DEPARTMENT OF
PLANNING AND DEVELOPMENT

SPECIAL PERMIT MODIFICATION
(P92-278)

APPLICATION: Planning Director's Modification of a Special Permit to allow construction of a 3,803 square foot veterinary hospital on 1.2± partially developed acres in the Rural Estates (RE 1/4) zone.

LOCATION: 7615 Sheldon Road

EXHIBIT - A SITE PLAN

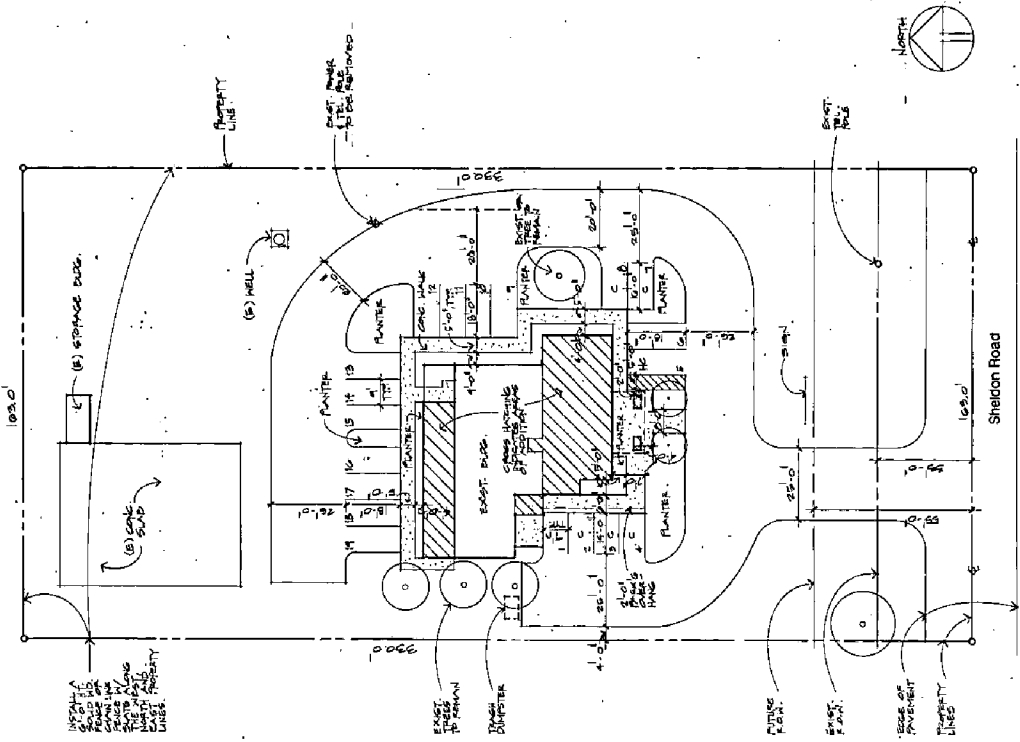
The submitted site plan places the building in the center of the site, with parking around the perimeter of the building. The applicant has revised his site plan to incorporate the parking and maneuvering areas required by the City. The County reviewed a special permit to reduce the parking requirements. The City, however, views veterinary hospitals as a medical use requiring one parking space for each 200 square feet. The 3,803 square foot veterinary hospital requires 19 parking spaces. The site plan indicates 19 spaces provided on site. It is unclear from the applicant's site plan how much of the area of the lot which is not used for parking is landscaped. The applicant shall submit a landscape plan for review and approval of the Planning Director prior to the issuance of Building Permits. The landscape plan shall indicate the required fifty percent tree shading of the parking and driveway areas, as well as all other landscape areas. The front setback area should be landscaped with a combination of trees, shrubs and groundcover to shield the driveway from view from the street. All portions of the property which are not landscaped or paved shall be barricaded from entry by a six inch concrete curb, fence, or bollards. No storage or parking is allowed on unpaved surfaces.

The City of Sacramento Zoning Ordinance requires that a six foot solid masonry wall be located along property lines which abut residential uses or zones. The site plan indicates a wood fence or chain link with slats. The site plan will need to be modified to indicate a solid masonry wall along the east, west, and northern property lines. The wall shall be located outside of the required front setback area.

The applicant has also indicated the proposed signage for the site. Staff has no objection to the location or design of the proposed monument sign. The Sign Ordinance, however, limits signage to 16 square feet for non-residential uses within a residential zone. The applicant's proposal consists of a 30 square foot (15' x 2') sign. The applicant should redesign the sign prior to the issuance of Sign Permits.

1. There shall be a minimum of 19 parking spaces provided on site.
2. The applicant shall submit a landscape plan for review and approval of the Planning Director prior to the issuance of Building Permits. The landscape plan shall indicate the required fifty percent tree shading of the parking and driveway areas, as well as all other landscape areas. The front setback area shall be landscaped with a combination of trees, shrubs and groundcover to shield the driveway from view from the street.

5. The site plan shall indicate a six foot ^{wood fence} ~~high solid masonry wall~~ along the north, east and west property lines. The wall shall not be located within the required front setback area.

7. The applicant shall submit a revised sign prior to the issuance of Sign Permits. The sign shall be a monument sign not exceeding 16 square feet in area.

EXHIBIT - B
ELEVATIONS

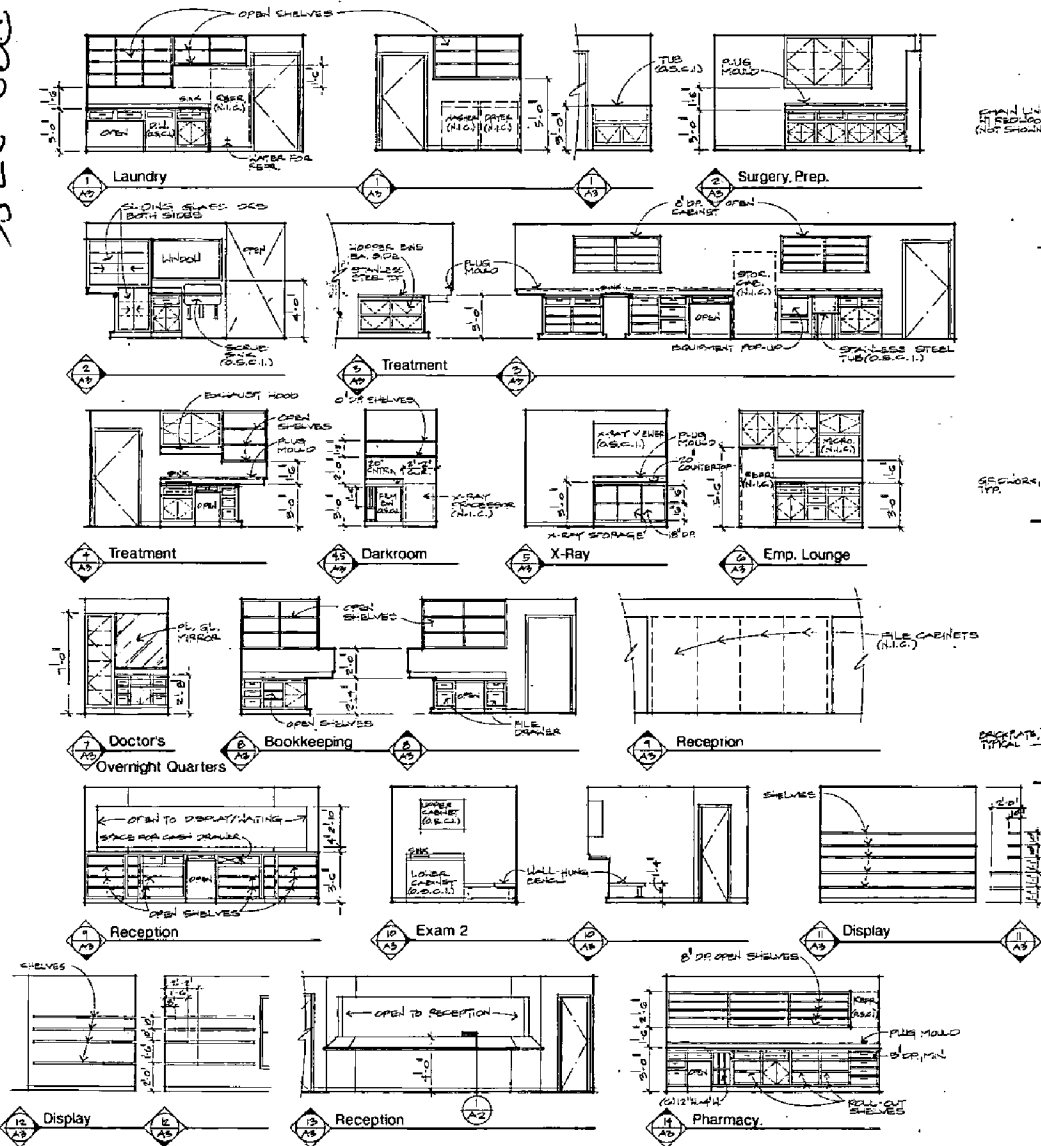
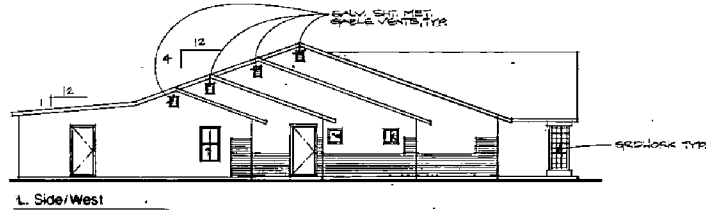
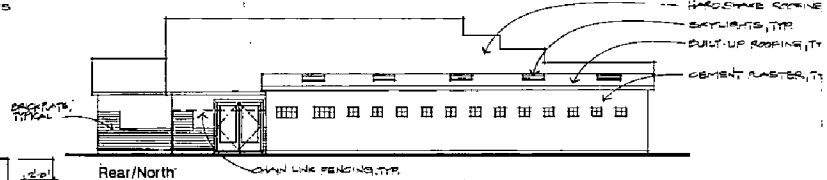
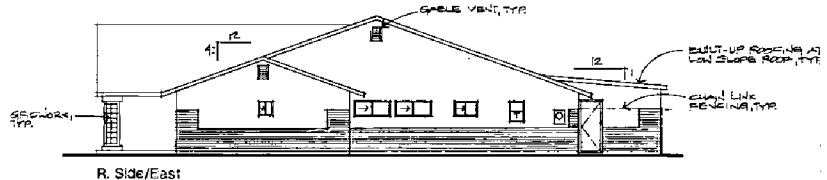
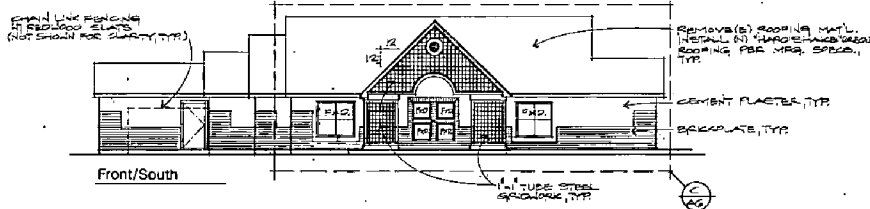
The proposed building is a single story building. The elevations indicate the exterior materials to be cement plaster with brick trim at the base. There is also steel gridwork which accents the main entrance. Staff has no objection to the proposed design of the building. The roof material is indicated to be "Hardshake" or something similar. If composition shingle roofing is proposed, it shall be a minimum 25 year rated laminated dimensional composition shingle.

6. The design of the structure shall be as per the submitted plans. If composition shingle roofing is proposed, it shall be a minimum 25 year rated laminated dimensional composition shingle.

TREE EXHIBIT

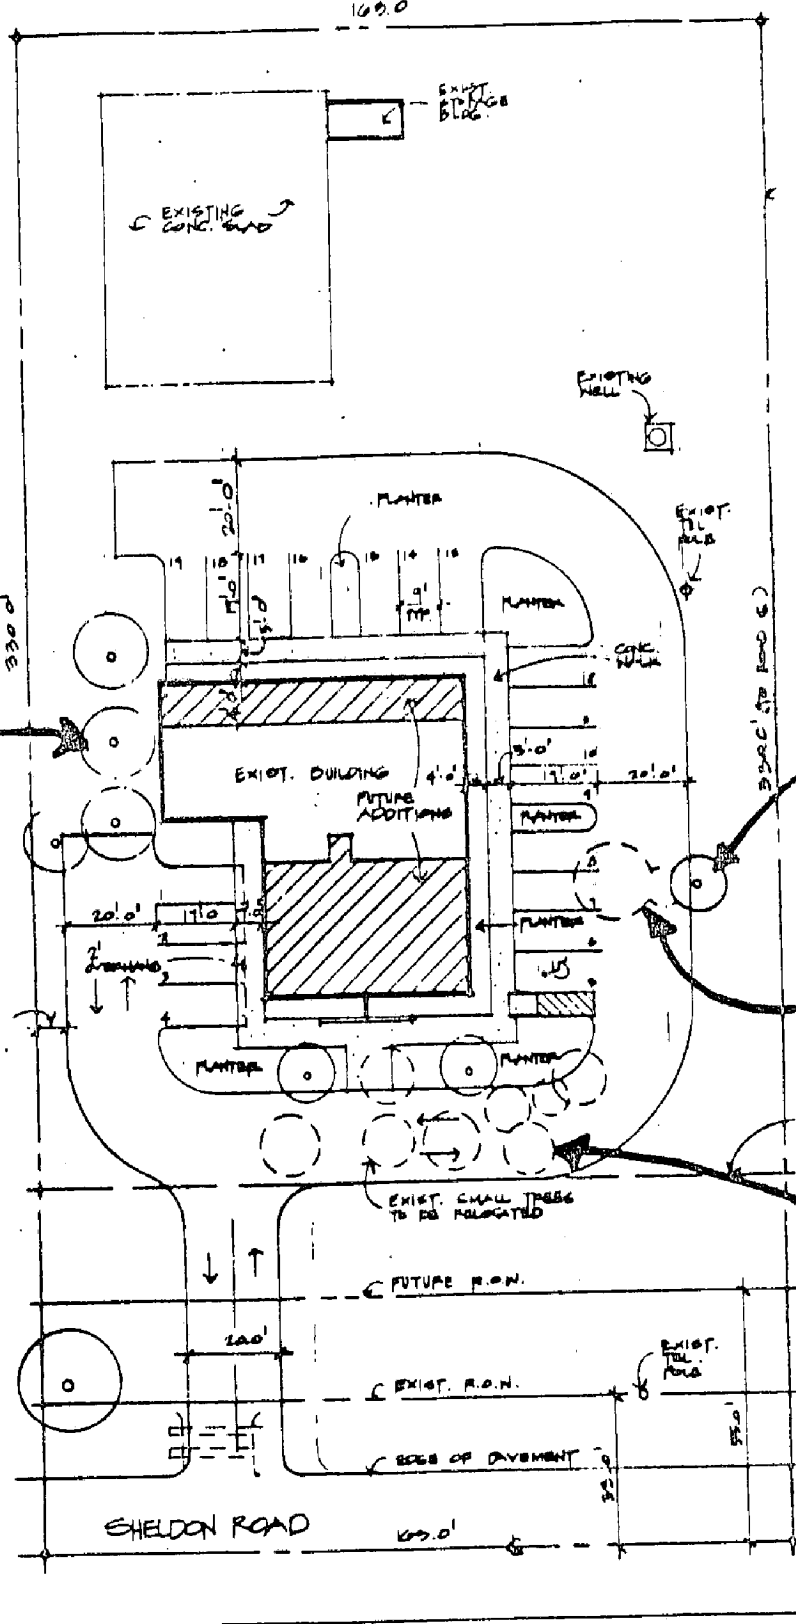
- A. To compensate for the removal of the 12 inch dbh oak tree the applicant shall plant twelve 15-gallon native oak trees (either valley oak/Quercus lobata or interior live oak/Q. wislizenii). Prior to the physical modification of the project site, a Replacement Oak Tree Planting Plan shall be prepared by a certified arborist or other professional tree expert and shall be submitted to the Planning Director for review and approval. The Replacement Oak Tree Planting Plan shall include at the minimum the following elements:

a. To compensate for the removal of the 12 inch dbh oak tree the applicant shall plant twelve 15-gallon native oak trees (either valley oak/Quercus lobata or interior live oak/Q. wislizenii). Prior to the physical modification of the project site, a Replacement Oak Tree Planting Plan shall be prepared by a certified arborist or other professional tree expert and shall be submitted to the Planning Director for review and approval. The Replacement Oak Tree Planting Plan shall include at the minimum the following elements:
